At your request, a visit was made to the referenced address on May 13, 2026, to inspect specific structural concerns noted in a recent home inspection report for the house that you are under contract to purchase. Public property records indicate this house was built in 1973. The following items were noted at the time of the inspection. All directions are in reference to a person facing the front of the house from the street.

Michael P. Gervais, P.E.
NC License #27399
Corporate License #: C3118
Enclosure: Repair Detail 'S1' 8x11

Add blocking between
joists

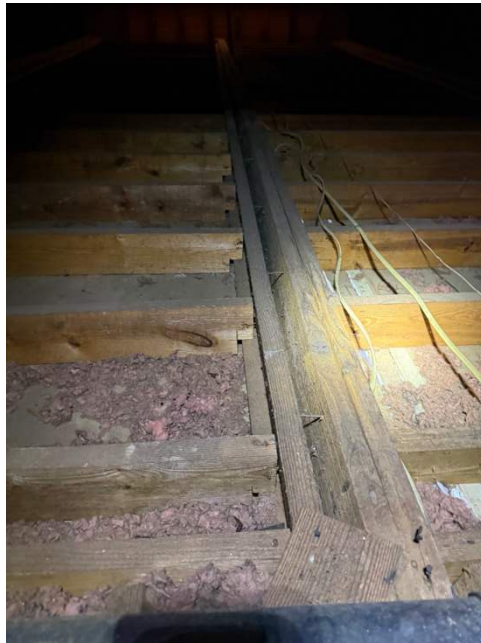
1. The home inspection report indicated a missing roof brace forward of the main center chimney. The roof framing in this area consists of 2x6 rafters spaced at 16 inches on center spanning a horizontal projected distance of approximately 13 feet 6 inches. This span is acceptable under current building code requirements for roof rafters without the need for intermediate bracing. Accordingly, no additional intermediate roof bracing is considered necessary. While inspecting this area, however, it was noted that the ceiling joists forward of the chimney do not have adequate blocking to brace them against rotation. A 2x6 band should be installed to tie the joists together over the top of the wall plate, or alternatively, solid blocking should be installed between the joists at this location. See the photo below.

Girder ply separation

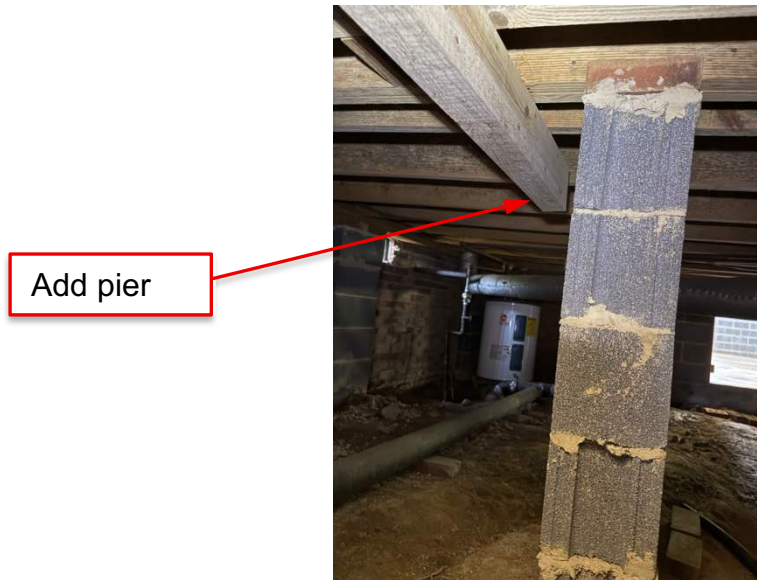
2. The ceiling framing over the garage consists of 2x6 ceiling joists framing into a center triple 2x8 girder. The girder plies have separated substantially, compromising the connection between the ceiling joists and the girder. As a result, the garage ceiling has cracked significantly. Measurements taken within the garage indicate that the front wall

is leaning outward approximately 1.25" to 1.5 inches, while the rear wall containing the garage doors remains plumb. Cracking observed in the front foundation wall suggests that the front footing has rotated outward rather than settled vertically. This condition has caused the top of the wall to pull outward, which in turn has contributed to the separation of the center garage girder and has been further exacerbated by the tension forces imposed by the roof framing. The existing connection at the center girder did not provide sufficient tensile capacity to restrain the top of the front wall against this movement.

This type of footing rotation is commonly associated with poor drainage conditions. Much of the front foundation wall was concealed by vegetation at the time of the inspection and should be cleared to expose the base of the wall. A qualified moisture mitigation specialist should evaluate drainage along the front side of the house and implement corrective measures to ensure that water is directed rapidly away from the foundation. Although the cracks in the front foundation wall are likely attributable to this footing movement, there is no indication that the underlying soils are soft or have inadequate bearing capacity. Accordingly, underpinning repairs are not recommended at this time. Improved drainage should help prevent further movement.

The ceiling framing over the garage is in a condition that presents a risk of collapse if not repaired. The existing girder should be removed and replaced with a wider multiply girder in accordance with the attached repair detail.

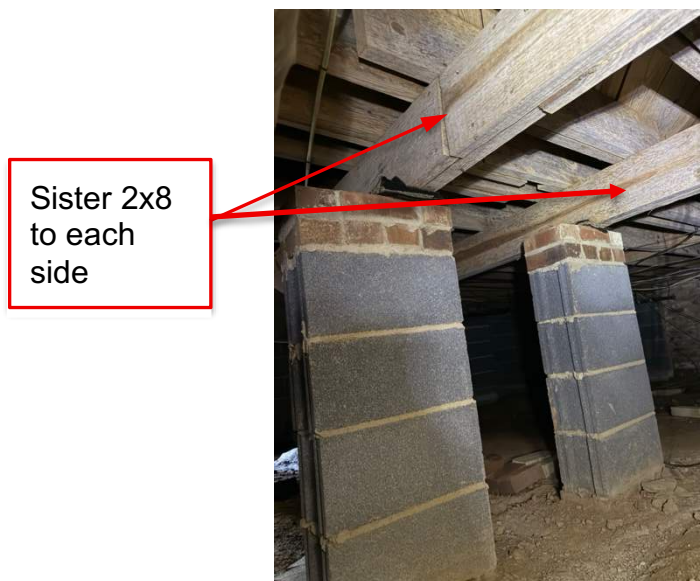
3. In the crawlspace, the intermediate dropped girder beneath the center of the front living room is not supported at either end. A masonry pier should be added at each end adjacent to the existing piers that were likely intended to support the girder. A similar condition exists at the intermediate dropped girder located to the right of the foyer. Each

end of this girder should also be supported with a masonry pier (4 piers total). Each pier should bear on 22"x22"x7" concrete footings. See the photo below.

4. The two center dropped girders to the left of the chimney are spliced at locations beyond the supporting pier, creating a structural weakness. In addition, the spans to the left of the piers are approximately 11 feet, which is excessive for the tributary loads imposed on these members. To correct these deficiencies, sister a 2x8 member to each side of both spliced girders to the left of the chimney. In addition, construct a masonry pier at the midpoint of the 11-foot span of each girder, bearing on a 22-inch by 22-inch by 7-inch concrete footing. These new piers will reduce the effective span to approximately 5 feet 6 inches, which is more appropriate for the applied loads.
